VERSATILE TEXTILES LTD.

10, Deger Chala, National university, Gazipur, Bangladesh
(23.964633N, 90.384902E)
01st Sep 2016

Inadequate Structural drawing (Factory Building)

Branching column connection with slab

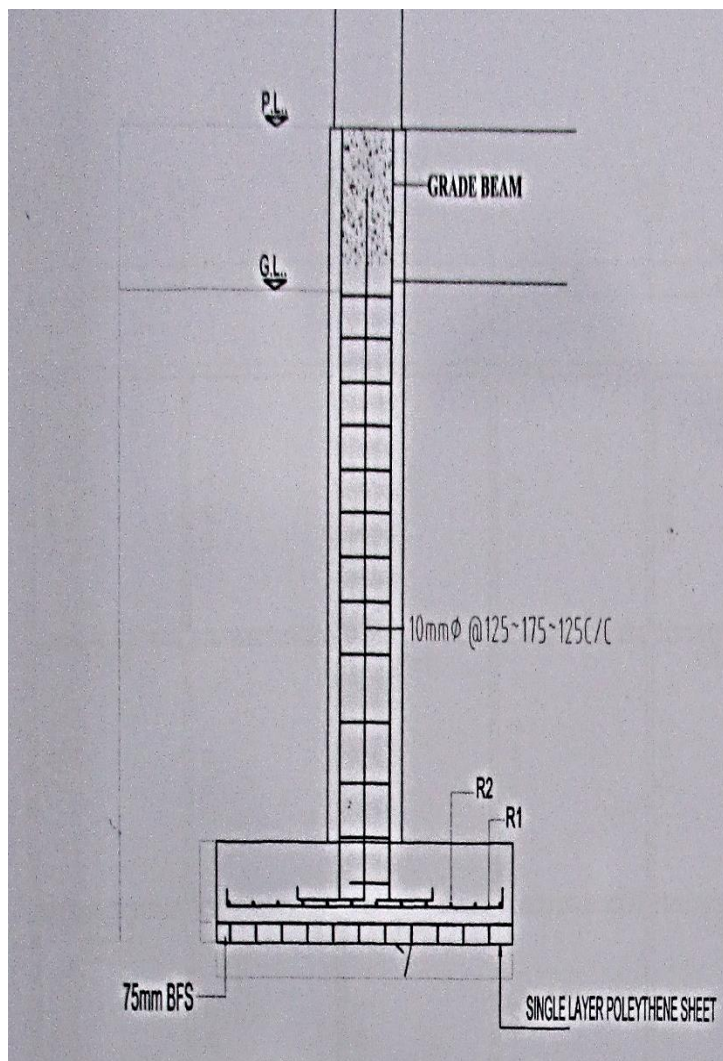
As Built Structural Drawings were not available for the steel roof shed & canopy. The connection between branching column of canopy and roof slab was not cleared also it was not mentioned in structural drawing.

Item No.	Observation	Recommended Action Plan	Recommended Timeline
1	Inadequate Structural drawing	Comprehensive As-Built drawings are to be produced as per as-built condition.	6-weeks
2	Inadequate Structural drawing	Factory engineer to assess the adequacy of the roof shed and Canopy as per BNBC.	6-weeks
3	Inadequate Structural drawing	Implement any remedial measures as per recommendations of the assessment.	6-months
4	Adequacy of the foundation system	Current loading should not be increased. Control loads with in 3kPa	Immediate - Now
5	Adequacy of the foundation system	Factory engineer to assess the adequacy of all foundations as per BNBC.	6-weeks
6	Adequacy of the foundation system	Implement any remedial measures as per recommendations of the assessment.	6-months

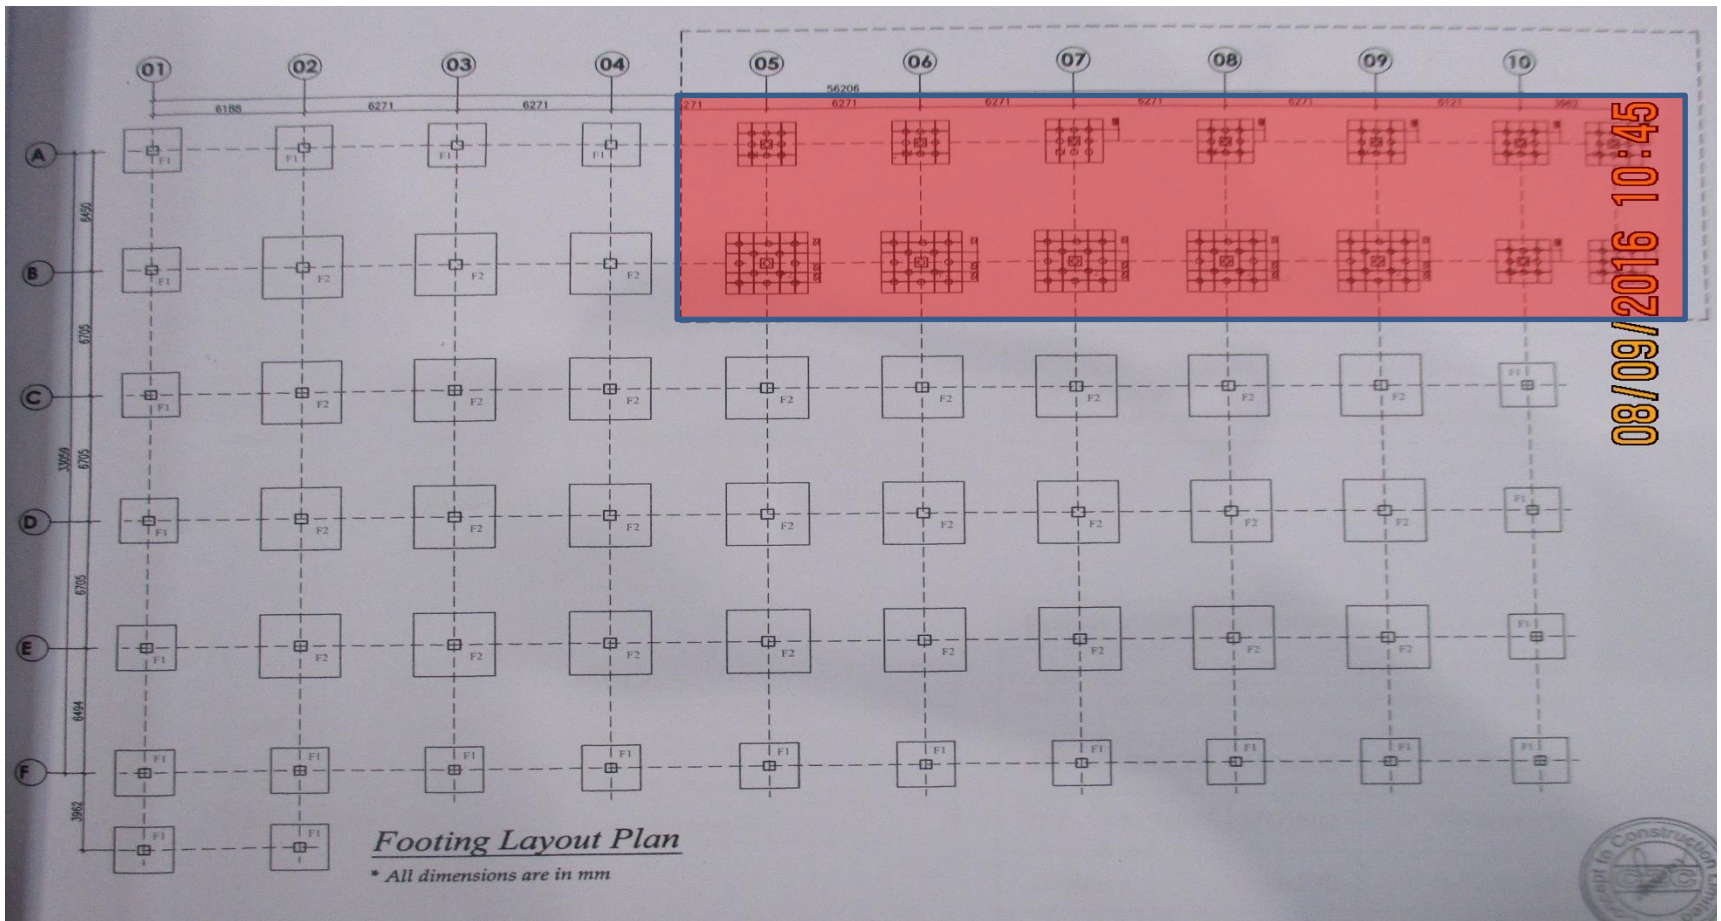
Soil test reports recommend shallow foundation or RC cast is situ piled foundation. But according to structural drawing it is found as wooden pile has been used in a portion of the foundation system of the building.

In some portions of foundation system, wooden piles were used to support isolated footings according to as-built structural drawings. But the detail of the wooden pile including capacity is not mentioned.
